# UNITED STATES PATENT AND TRADEMARK OFFICE

APPLICATION NO.	FILING DATE	FIRST NAMED INVENTOR	ATTORNEY DOCKET NO.	CONFIRMATION NO.
10/668,439	09/23/2003	Terry Lynn Luscombe	300323TG	2341

<b>Office Action Summary</b>	<b>Application No.</b>	<b>Applicant(s)</b>	
	10/668,439	LUSCOMBE, TERRY LYNN	
	<b>Examiner</b>	<b>Art Unit</b>	
	Hilary Gutman	3612

## DETAILED ACTION

Fig 1

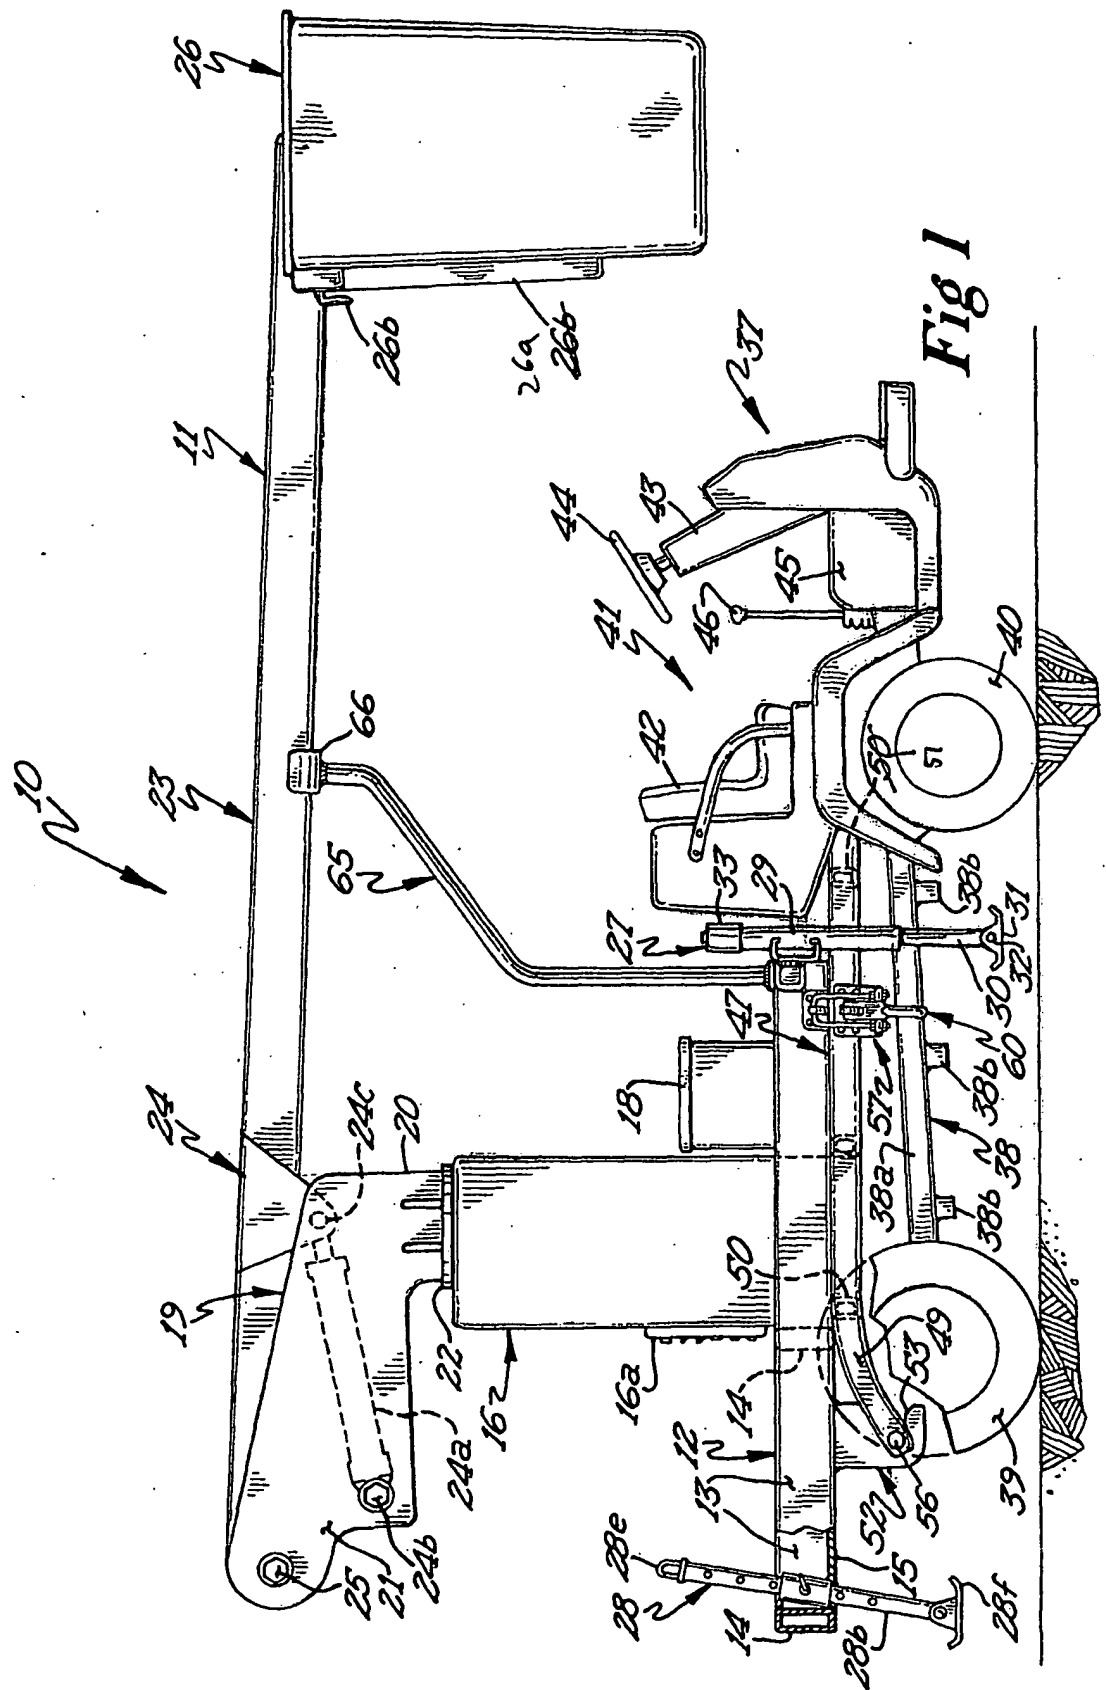
4. The drawings are objected to because in Figure 1, right-hand-most number "50" should be "51". Also in Figure 1, lower-most number "26b" should be "26a". In Figure 3, "50" should

be "51". Corrected drawing sheets in compliance with 37 CFR 1.121(d) are required in reply to the Office action to avoid abandonment of the application. Any amended replacement drawing sheet should include all of the figures appearing on the immediate prior version of the sheet, even if only one figure is being amended. The figure or figure number of an amended drawing should not be labeled as "amended." If a drawing figure is to be canceled, the appropriate figure must be removed from the replacement sheet, and where necessary, the remaining figures must be renumbered and appropriate changes made to the brief description of the several views of the drawings for consistency. Additional replacement sheets may be necessary to show the renumbering of the remaining figures. Each drawing sheet submitted after the filing date of an application must be labeled in the top margin as either "Replacement Sheet" or "New Sheet" pursuant to 37 CFR 1.121(d). If the changes are not accepted by the examiner, the applicant will be notified and informed of any required corrective action in the next Office action. The objection to the drawings will not be held in abeyance.
